1. APPLICATION IS: Development Project Protest Appeal

Development Address: 905 Bingham St

Project Description: Change of use to multi-unit dwelling

Development Activities Meeting

PLT
 PLOT &
 PARKING PLAN

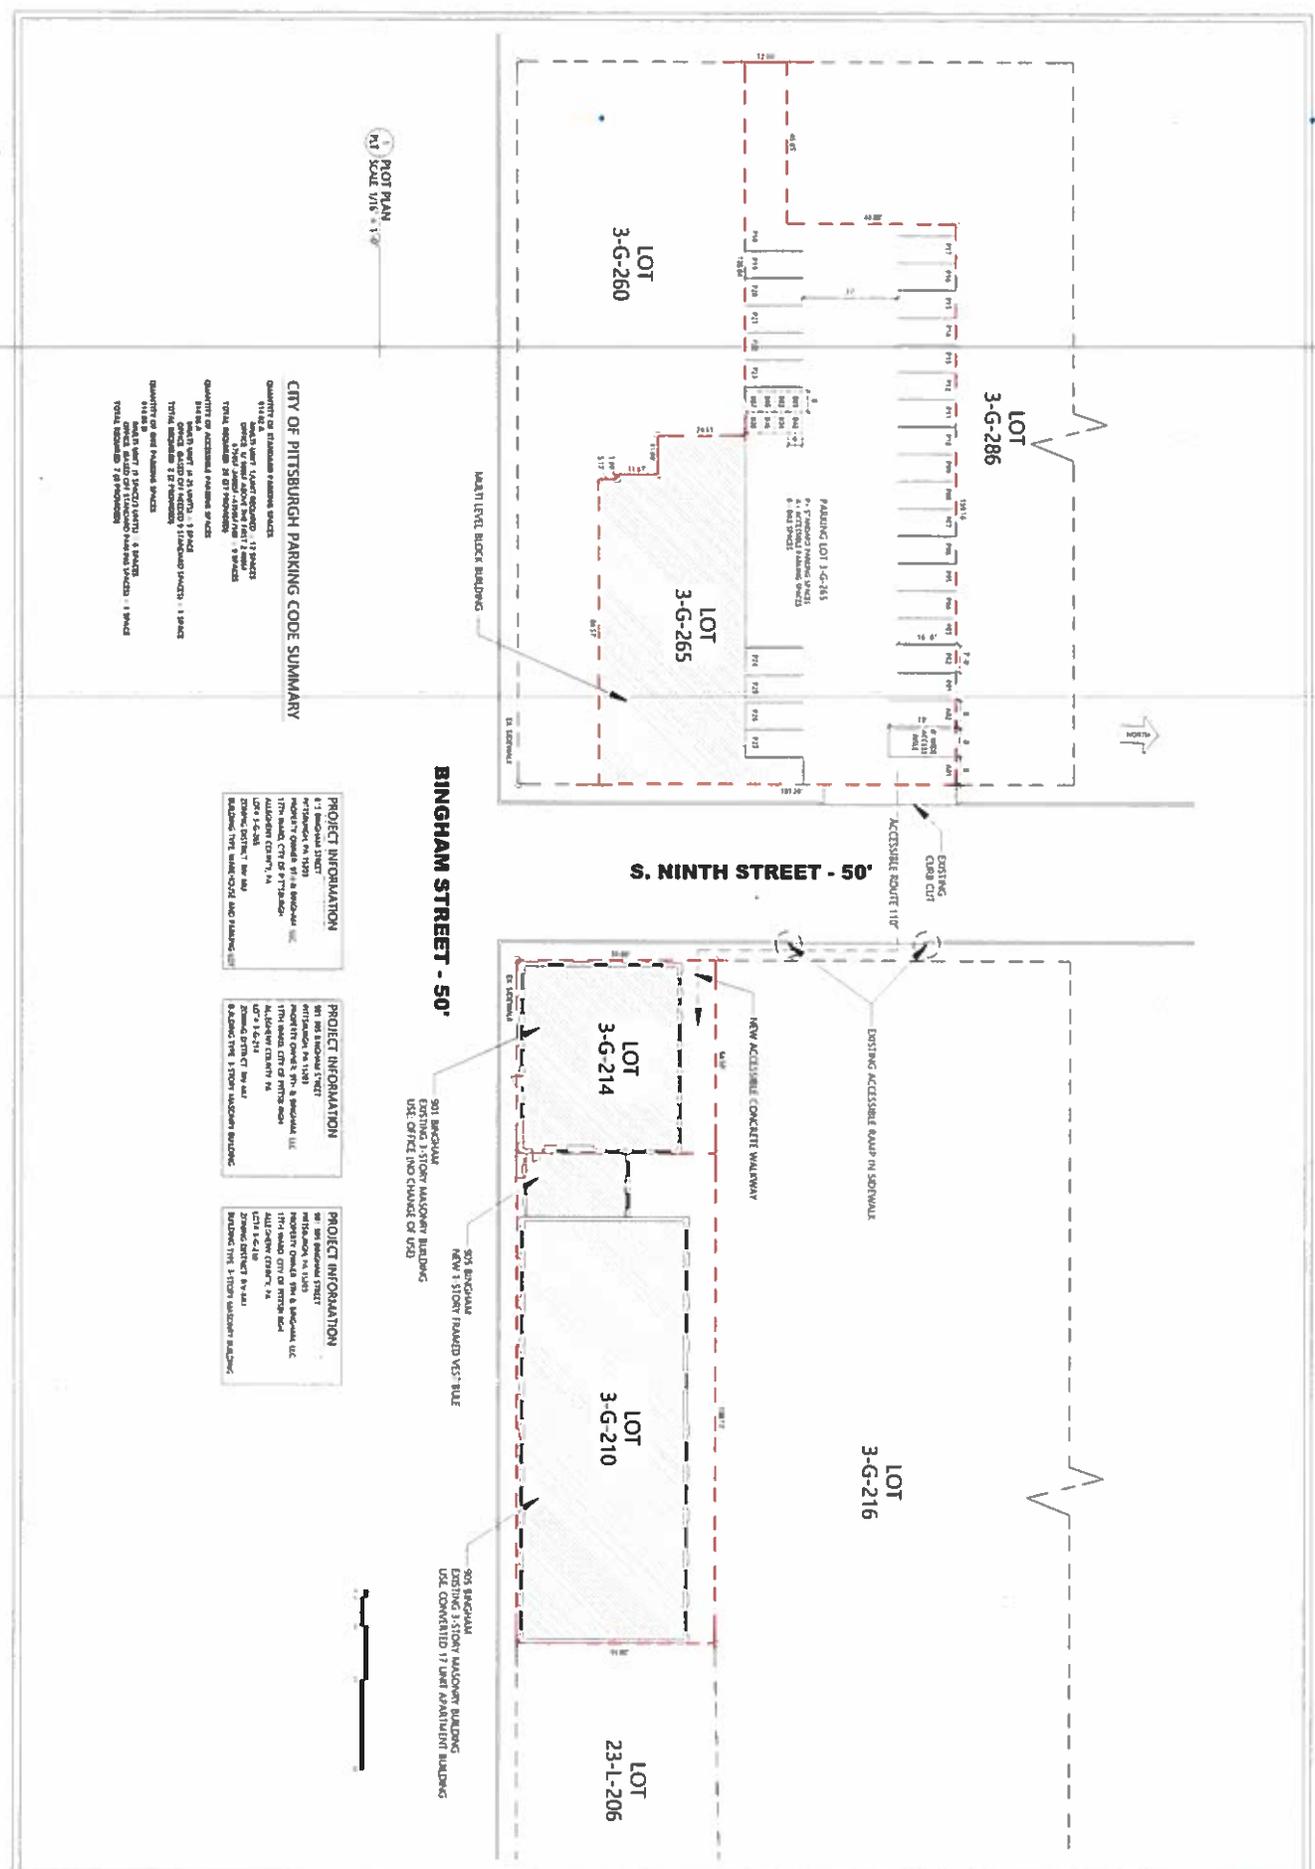
Where is your proposed parking lot?	Applicant explained.
What's the plan with the white building? Do you guys own that building? What is the plan since loading docks empty onto the parking lot? Is the white building vacant or occupied?	Yes, we own the white building. It is currently half occupied. We will do what we need to do for our parking.
Do the spots hit the RIV guidelines?	I don't know the answer to that... would have to get back to you.
I think there is a maximum in the RIV and a maximum size for surface lot. I think you have to be careful. I want to make sure we are looking at the right variance(s).	I'm sure the ultimate design will met those requirements.
Happy that something is being done with the buildings. Is there asbestos inside?	No, not much left inside. Will still be tested.
